LeeTran Transfer Stations

Fort Myers Beach Park and Ride
Cape Coral Transfer Station
Rosa Parks Transportation Center
Edison Mall Transfer Station

February 2022

Appendix A: Barriers to Accessibility Assessment Report

Location: Benches

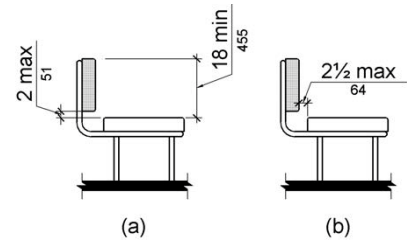
2010 ADA Standards for Accessible Design Codes: §903.4

The benches and stools do not have backs.

Ensure that a minimum of 5% of the seating in each area and of each type are accessible, which entails having back support that is 42" long minimum extending from a point 2" maximum above the seat surface to a point 18" minimum above the seat surface. Install a table that has wheelchair accessible seating with a clear floor space of 30" x 48" with a slope not steeper than 2% and that the tables have sufficient knee and toe clearance.

Location: Employee Door

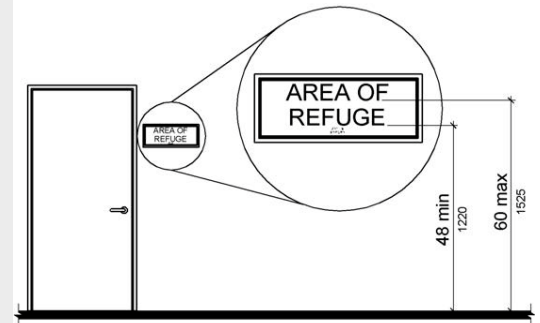
2010 ADA Standards for Accessible Design Codes: §216.2, §703

There are no tactile signs identifying the permanent rooms.

Install tactile signage on the latch side of the doorway at a height of 48" minimum to 60" maximum above the floor, identifying room by name or room number.

Signs shall be Braille with raised lettering and should be placed on the wall in the center of an 18"x18" clear floor space.

Location: Employee Door

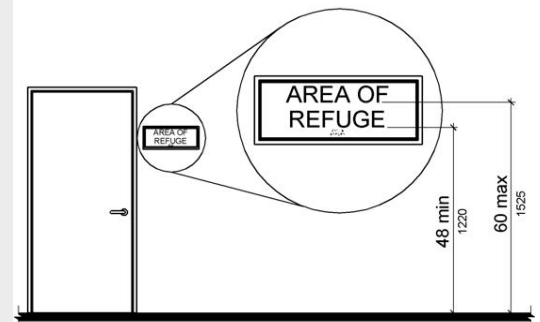
2010 ADA Standards for Accessible Design Codes: §216.2, §703

There are no tactile signs identifying the permanent rooms.

Install tactile signage on the latch side of the doorway at a height of 48" minimum to 60" maximum above the floor, identifying room by name or room number.

Signs shall be Braille with raised lettering and should be placed on the wall in the center of an 18"x18" clear floor space.

Location: Men's Restroom

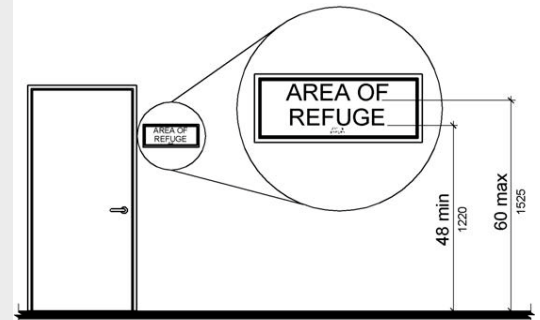
2010 ADA Standards for Accessible Design Codes: §216.4, §703

Doors serving as exits are not marked by tactile signage.

Place a tactile exit sign on the latch side of the doors, that complies with §703.1, §703.2 and §703.5, identifying the exit doors.

Install missing signage at 48" minimum above the floor measured from the baseline of the lowest character and 60" maximum measured from the baseline of the highest character.

Location: Men's Restroom

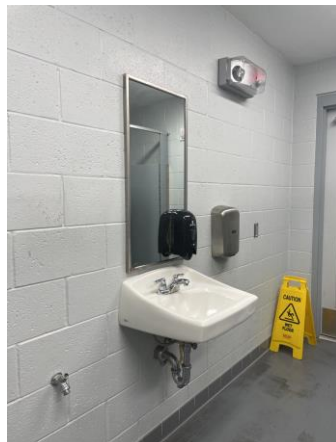
2010 ADA Standards for Accessible Design Codes: §606.3

The sink is 37" above the floor.

Lower the sink to ensure that the higher of the rim is a maximum of 34" above the floor.

Location: Men's Restroom

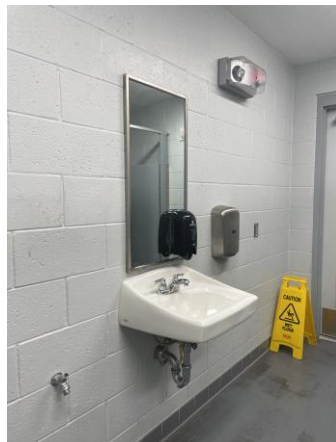
2010 ADA Standards for Accessible Design Codes: §606.5

The pipes under the sink are not insulated from being touched by a person using a wheelchair.

Wrap the pipes beneath the sink with soft protective wrap or plastic.

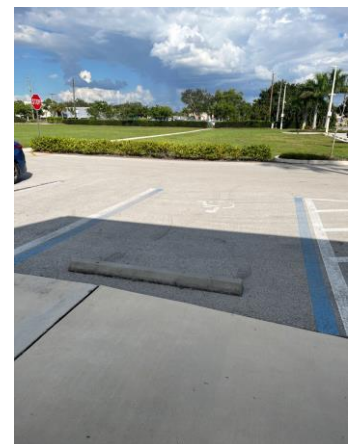
2010 ADA Standards for Accessible Design Codes: §502.4, FAC/FBC 502.2

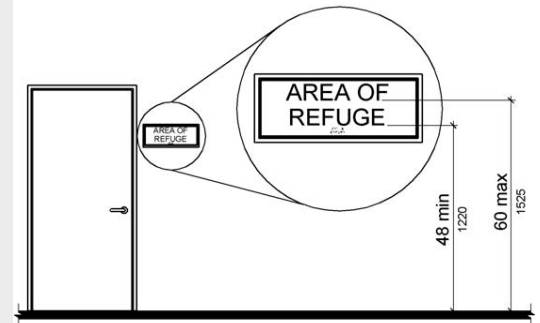
2010 ADA Standards for Accessible Design Codes: §216.4, §703

Doors serving as exits are not marked by tactile signage.

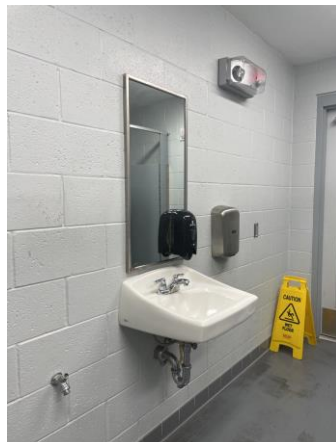
2010 ADA Standards for Accessible Design Codes: §606.3

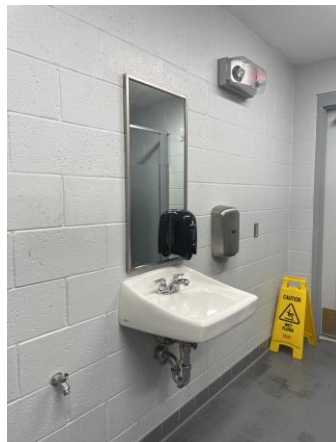
2010 ADA Standards for Accessible Design Codes: §606.5

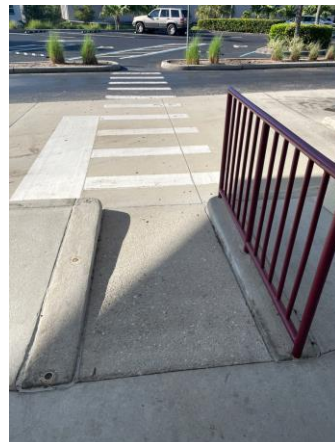
2010 ADA Standards for Accessible Design Codes: §405.2

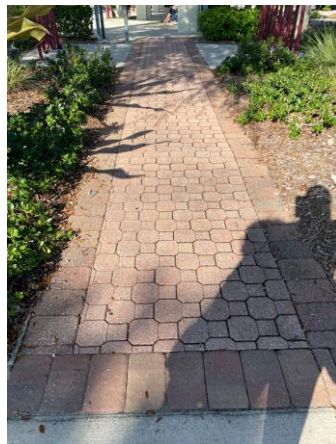
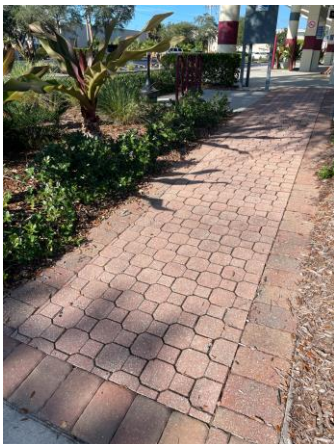
2010 ADA Standards for Accessible Design Codes: §403.3

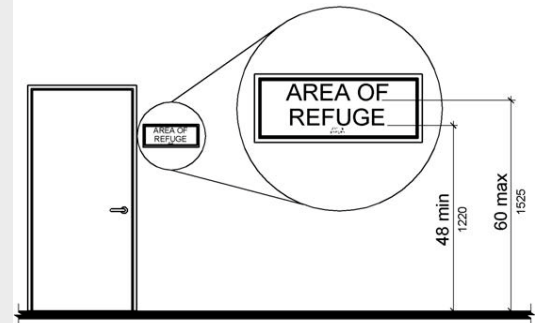
2010 ADA Standards for Accessible Design Codes: §216.2, §703

There are no tactile signs identifying the permanent rooms.

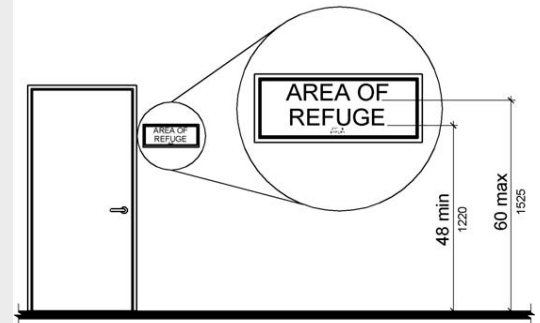
2010 ADA Standards for Accessible Design Codes: §216.2, §703

There are no tactile signs identifying the permanent rooms.

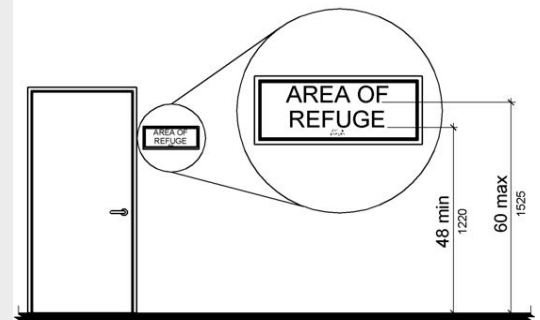
2010 ADA Standards for Accessible Design Codes: §216.2, §703

There are no tactile signs identifying the permanent rooms.

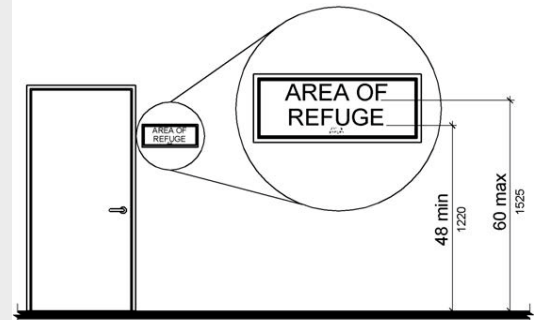
2010 ADA Standards for Accessible Design Codes: §216.2, §703

There are no tactile signs identifying the permanent rooms.

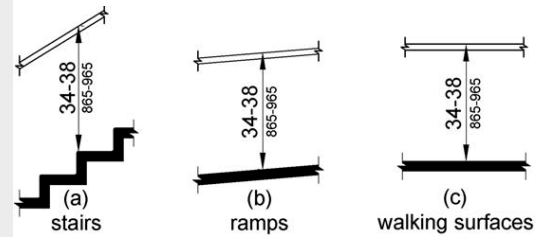
2010 ADA Standards for Accessible Design Codes: §405.2, §505.2

There are no handrails.
The running slope of the ramp is 9.6%.

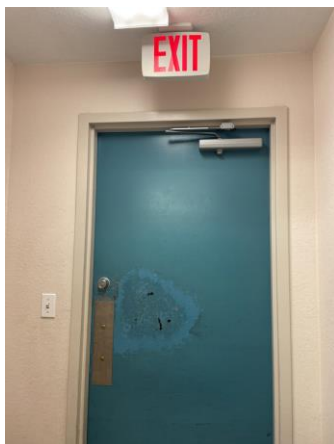
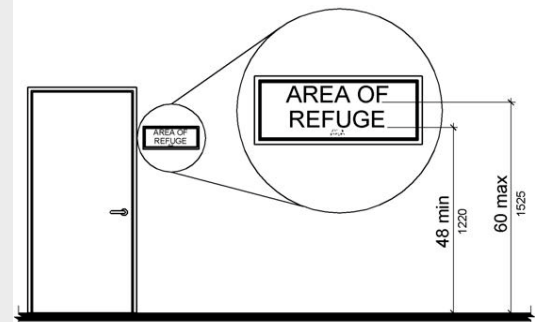
2010 ADA Standards for Accessible Design Codes: §216.4, §703

Doors serving as exits are not marked by tactile signage.

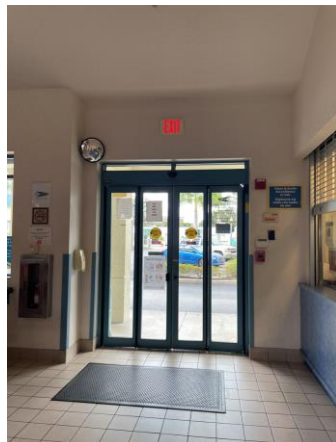
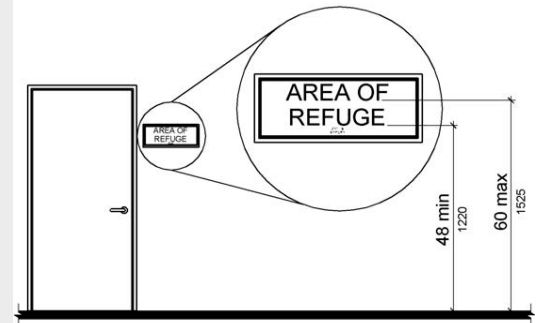
2010 ADA Standards for Accessible Design Codes: §216.4, §703

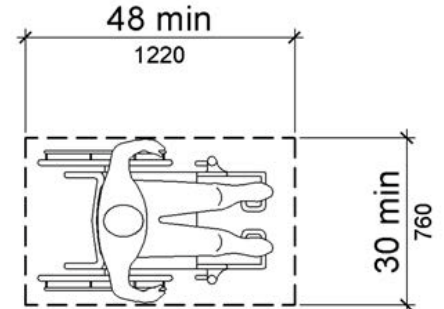
2010 ADA Standards for Accessible Design Codes: §305.2

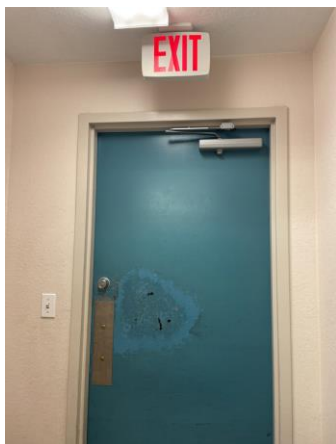
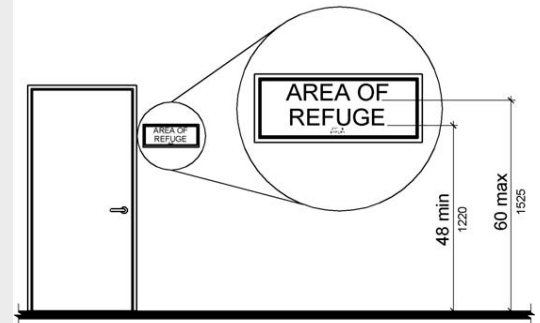
2010 ADA Standards for Accessible Design Codes: §216.4, §703

Doors serving as exits are not marked by tactile signage.

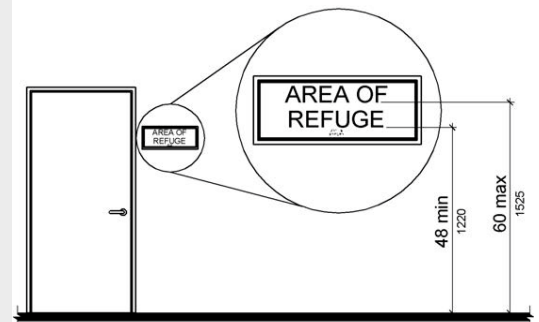
2010 ADA Standards for Accessible Design Codes: §216.2, §703

There are no tactile signs identifying the permanent rooms.

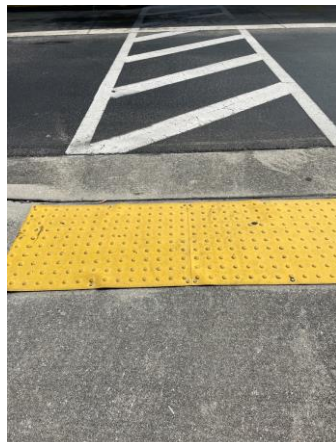
2010 ADA Standards for Accessible Design Codes: §705

The detectable warnings are faded and uplifting.

Replace the detectable warning. Ensure that it contrasts visually with the adjacent surface with either light-on-dark, or dark-on-light.

Ensure that the change in level does not exceed 1/4" and that the detectable warning is flush with the surface of the sidewalk to ensure that it does not act as a tripping hazard.

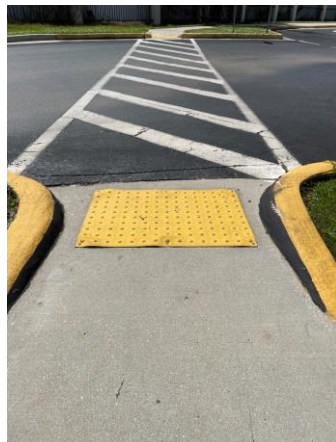
2010 ADA Standards for Accessible Design Codes: §705

Replace the detectable warning. Ensure that it extends the full width of the curb ramp.

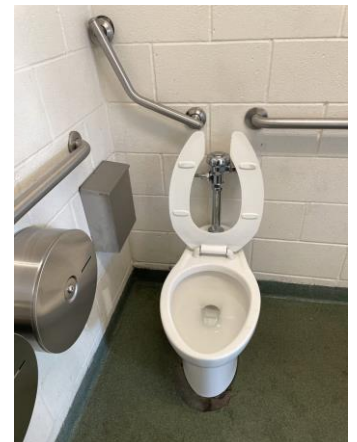
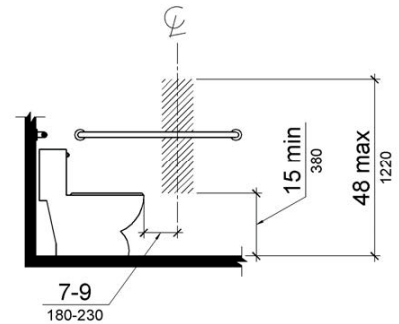
2010 ADA Standards for Accessible Design Codes: §604.7

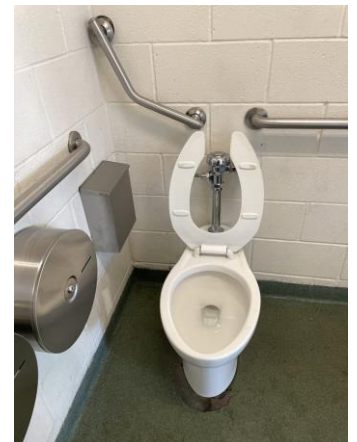
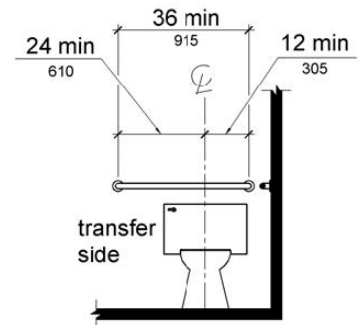
2010 ADA Standards for Accessible Design Codes: §604.5.2

Replace the rear grab bar with one that is a minimum of 36" long and extends from the centerline of the water closet 12" minimum on one side and 24" minimum on the other. Note: The diagonal grab bar can be removed.
